RE: Staff Letter dated December 29<sup>th</sup>, 2009 written by ICC Evaluation Service's Staff Engineer, Dr. Mahmut Ekenel

RE: Letter dated January 18<sup>th</sup>, 2010 written by Thermomass's Director of Engineering, Venkatesh Seshappa

I would also like to take this opportunity to remind you that the intent of AC422 is to develop an Acceptance Criteria (AC) and Evaluation Service Report (ESR) for the interaction of carbon fiber grid, concrete, and insulation. The results of any ESR related to AC422 would be specific for a given specimen based on the material properties of the insulation, insulation thickness, material properties of the concrete, spacing of the grid strips, and grid properties including spacing, orientation, and strength. In addition, the AltusGroup® is comprised of a number of individual company members under confidentiality. These member companies have access to proprietary research and design information specific to our group. The intent was never to expose this information but develop an accepted method to determine specific design properties that are most crucial the behavior of some of some of our proprietary designs. There are a number of tests that Mr.

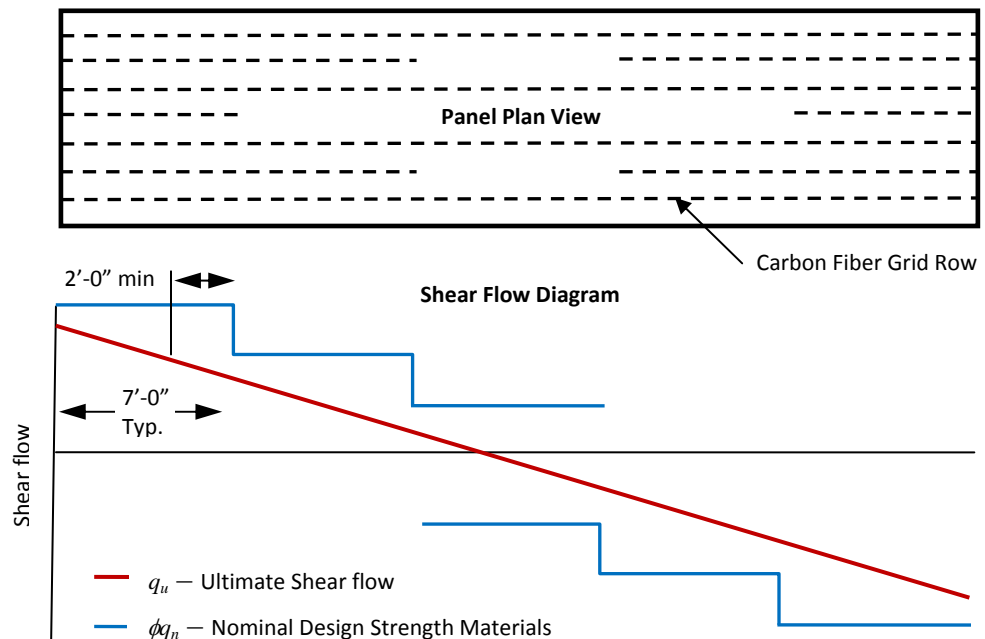
From a design perspective the carbon fiber grid is used to resist internal shear flow,  $q_u$ . This shear flow is not constant from one end of the member to the other, based on forces and connections there is typically a maximum shear flow at the ends and zero shear flow in the center of the span. In typical designs the quantity or rows of grid will be reduced as you approach zero shear flow. The 7 foot length is a good representation of this decrease while adding some redundancy to the design as our normal procedure would be to taper off rows in about 5 foot to 7 foot increments as shown in the following figure.
